Reference: 22.182r01v01

Re: 488-492 Old South Head Road, Rose Bay

Proposed Temporary Woolworths Neighbourhood Supermarket

Council Reference: Application No. 140/2022

ATTACHMENT 2 RBAG Photographic Records

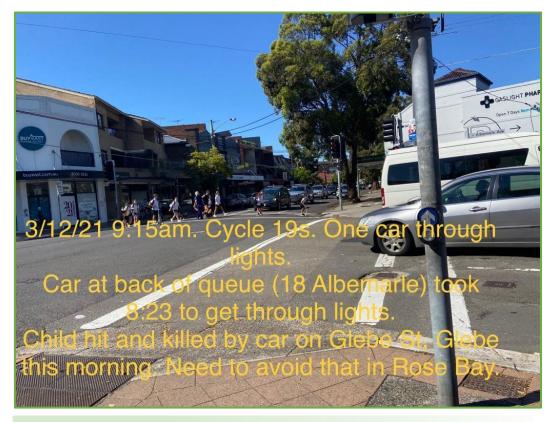
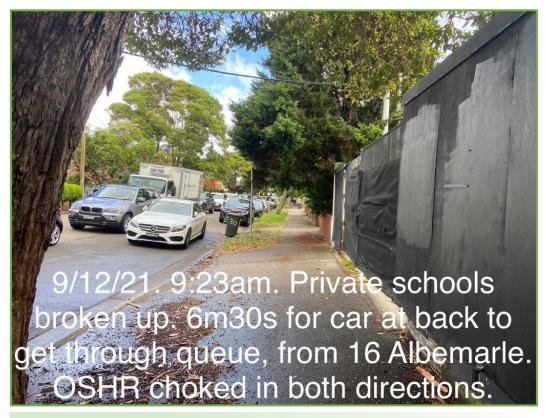
Further to the above, we note the substantial 95th percentile queue informed by the traffic models is generally consistent with RBAG's observations provided in **Attachment 2**.
